Product Change Notification

PCN-IFC-2626-2018

Business Unit	Product Line Code	Type of Change	Action	Date of Issue
IFC - Industrial Field Connectivity	BF7	Product Change Notification	Notify Distributors and Field	11/29/2018

Description for Product Change Notification

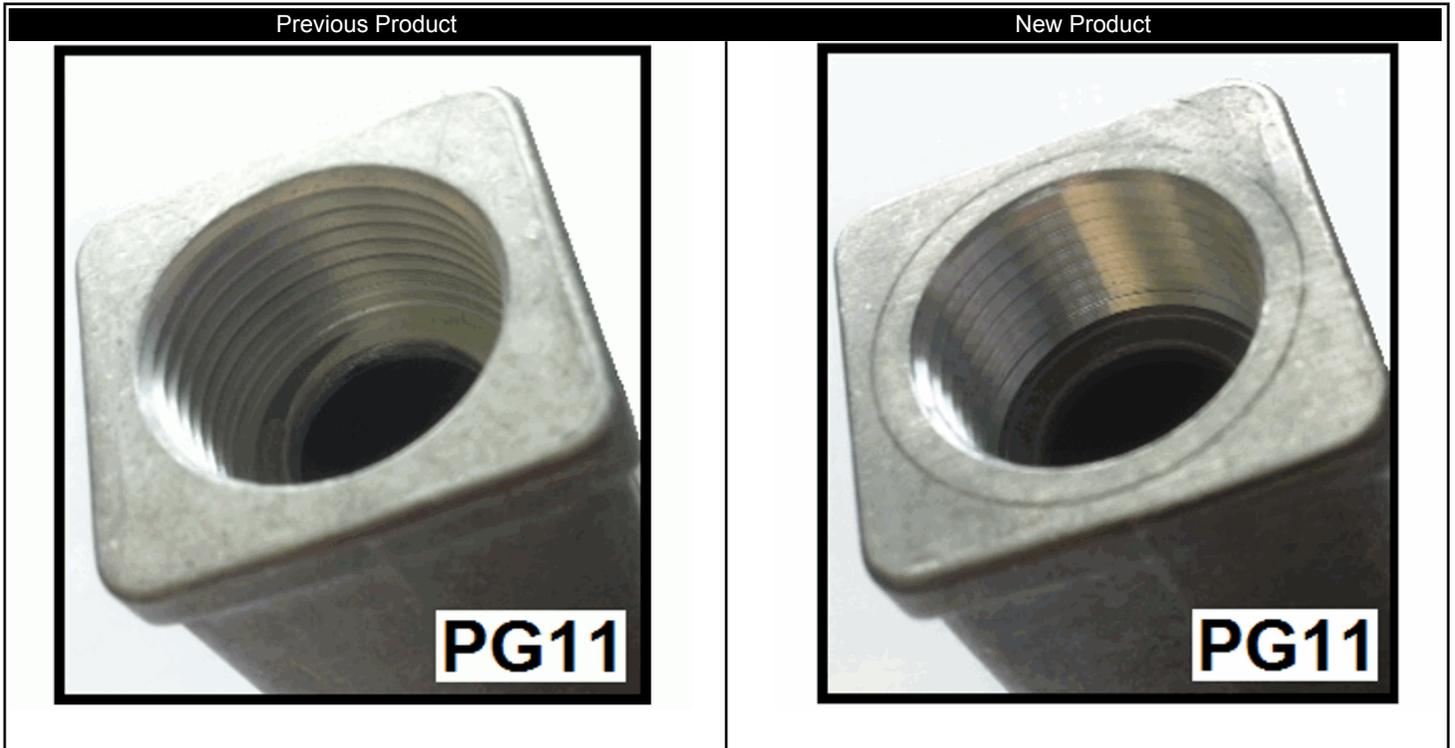
Currently, both the M20 and PG11 threaded D7 housings look nearly identical. To allow for easier identification, we will be adding a ring into the metal around the **PG11** cable entry. The M20 housings will remain unchanged. Version code (V/C) will change from 00 to 01.
